QUARANTINE NOTICE

Reference number:	QN-01-0056	Issued: 24 March, 2017
Subject:	Possible missing fuel line heat deflector	
Model(s):	V12 Vantage S and Vanquish	
VIN Range:	Refer to the list of applicable VIN published separately.	
Applicable to:	All Dealers	
Distribute to:	After Sales Manager Executive Manager Service Manager Sales Manager	Warranty Staff Technician(s) Parts Staff

Figure 1

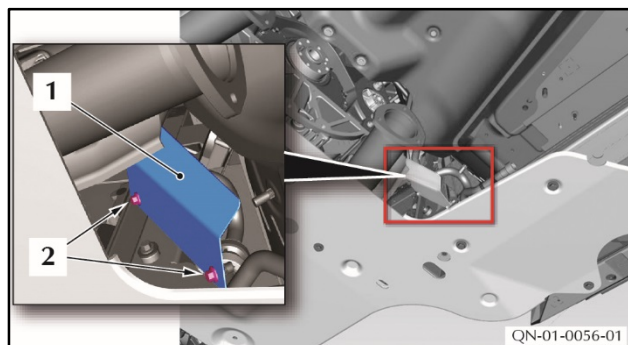
Because of an error during manufacture, it is possible that some of the vehicles in the affected VIN list do not have the heat deflector installed for the fuel line.

1. Lift the vehicle and make it safe.
2. Refer to Figure 1 and examine the area at the corner of the floor pan where the fuel pipe goes into the engine bay.
3. If the heat deflector (1) is installed, you do not need to do more work. If the heat deflector (1) is not installed, do the steps that follow.

4. Put the heat deflector (1) in position.
5. Install and torque the two M6 attachment screws (2) to 9 Nm.
